PLANNING & INSPECTIONS DEPARTMENT CONSOLIDATED REVIEW COMMITTEE STAFF REPORT

Case No: PLRG25-00009
CRC Hearing Date: December 10, 2025
Staff Planner: Alejandra González, 915-212-1506, GonzalezAG@elpasotexas.gov
Location: 511 Blanchard Ave.
Legal Description: The East 52 feet of Lots 16 through 20, Block 149, Alexander Addition
City of El Paso, El Paso County, Texas
Acreage: 0.15 acres
Zoning District: R-4/NCO (Residential/Neighborhood Conservancy Overlay)
Existing Use: Single-family residence
Project Description: Additions and exterior remodeling of the existing residence and garage
Property Owner: Alan Heatley
Representative: Jorge Eduardo Enriquez

Front Elevation

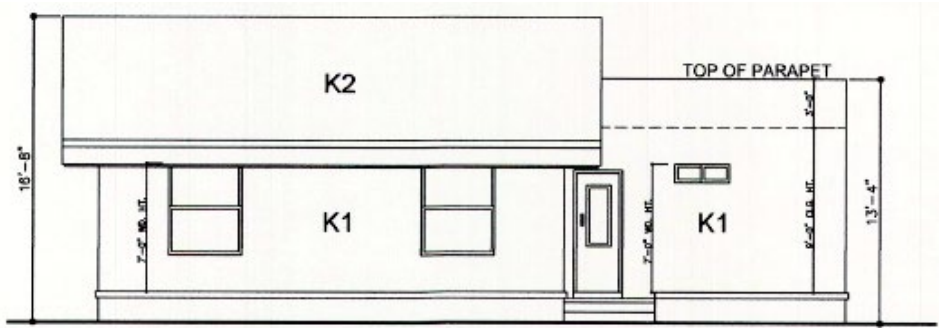
- *That the front porch must remain intact to maintain the design and character of the main dwelling.*
